MEMORANDUM

January 23, 2014

TO: Planning, Housing, and Economic Development Committee
FROM: Glenn Orlin, Deputy Council Administrator⁶⁰
SUBJECT: Bethesda Purple Line Station Plan—transportation issues

Figure 5: Capital Crescent Trail Tunnel Option 1

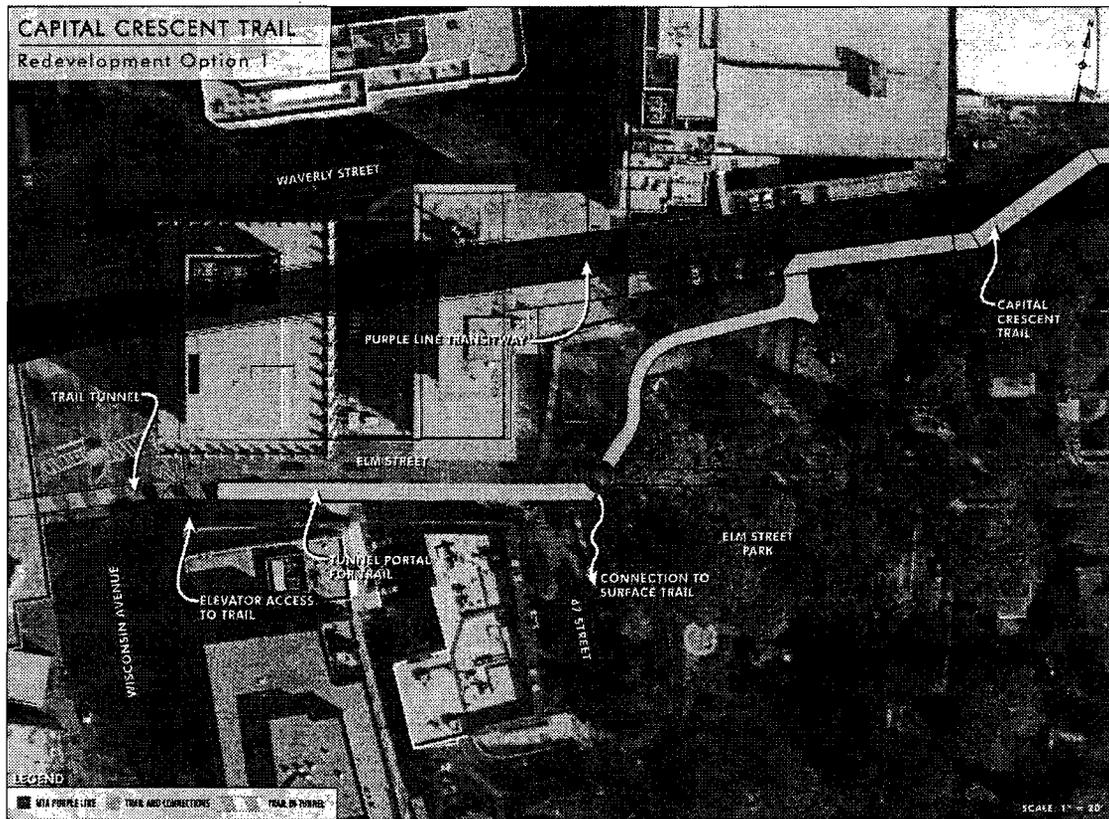
The Planning staff conducted a thorough analysis of the two new trail options (©X-X). Of the trail options, the Planning Board recommends Option 1. Council staff concurs, not only because it would be only half the cost, but because of the better personal security afforded by a shorter and straighter tunnel. In its testimony the Coalition for the Capital Crescent Trail was correct in pointing out that the grade emerging from the tunnel should be less than 5%, not the 8% it would be if it returned to grade short of the 10-space parking lot on the south side of Elm Street midway between Wisconsin Avenue and 47th Street. The County should work with the property owner to find a comparable location for these 10 spaces so the access to the lot can be closed off.

Intersection of Wisconsin Avenue / East-West Highway / Old Georgetown Road

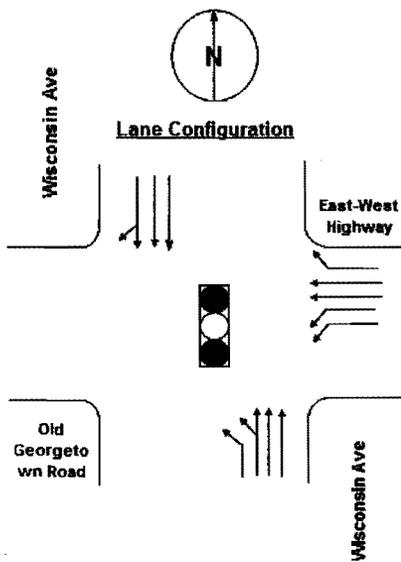
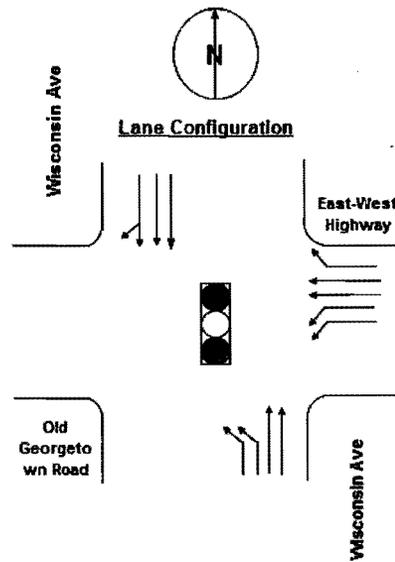
At two other intersections, the standard can be met merely by reassigning how the existing lanes are used. At Wisconsin Avenue/East-West Highway/Old Georgetown Road, the intersection is forecasted to operate at 1.20 and 1.22 v/c in the AM and PM peaks, respectively. Currently the northbound approach on Wisconsin Avenue has an exclusive left-turn, a combination left/through-lane, and two through lanes. If the combination left/through lane were to be designated as a second left-turn lane, then the v/c ratios would improve to 1.05 and 0.97, respectively.

(1) Northbound Direction: Revise lane configuration from Left, Left/Through, Through, Through to Left, Left, Through, Through

Intersection of Wisconsin Avenue / Bradley Blvd

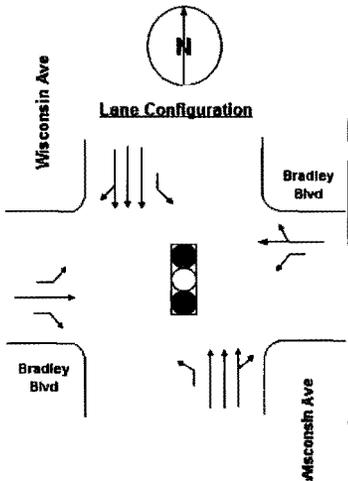
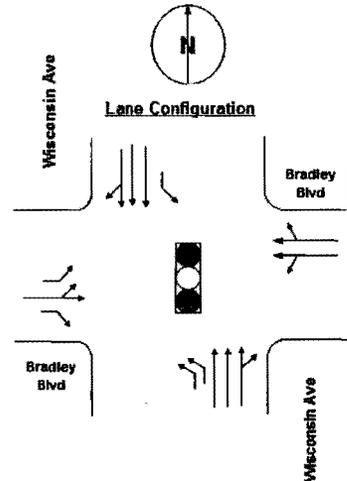
The only intersection widening identified by the analysis would be on the south leg of Wisconsin Avenue at Bradley Boulevard, where a second northbound-to-westbound left-turn would be needed to bring the intersection in compliance with the 1.13 v/c standard. This would mean adding 10’ to the road’s cross-section: perhaps 5’ from each side (abutting the fire station to the west and the Chevy Chase Club to the east).

(1) Northbound Direction: add 2nd left turn lane

Intersection of Bradley Blvd / Arlington Road

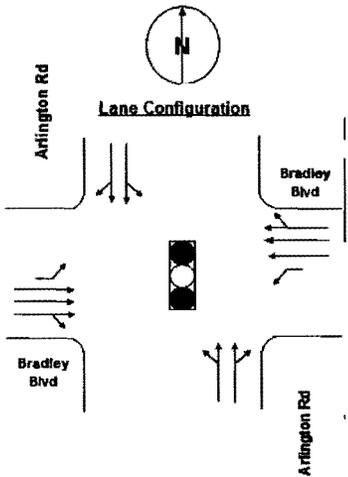
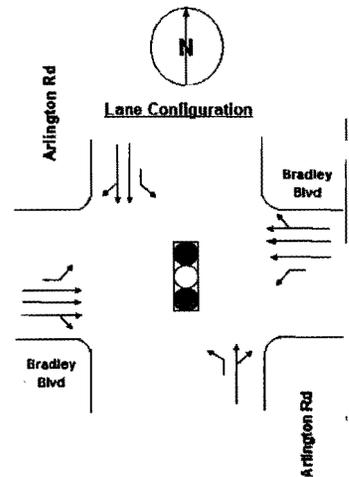
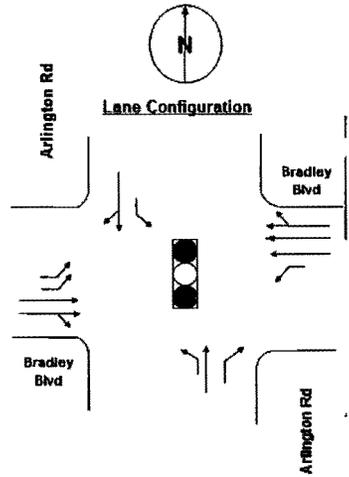
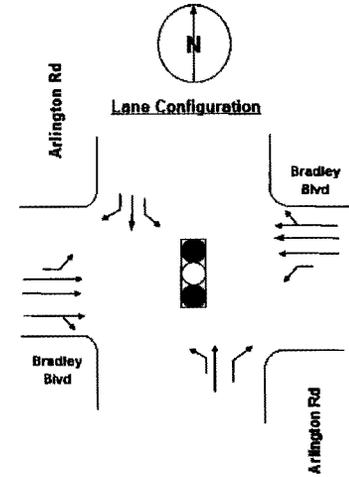
Bradley Boulevard/Arlington Road is forecasted to operate at 1.17 and 1.71 v/c in the AM and PM peaks, respectively. Here the solution is dynamic lane assignment: changing how some of the lanes on the northbound and southbound approaches on Arlington Road are utilized between the AM and PM peaks. With the reassignment, the v/c ratios would improve to 1.08 and 1.13, respectively.

(1) Southbound Direction: Revise land configuration from Left/Through, Through/Right to Left, Through, Through/Right

(2) Dynamic Lane Use:
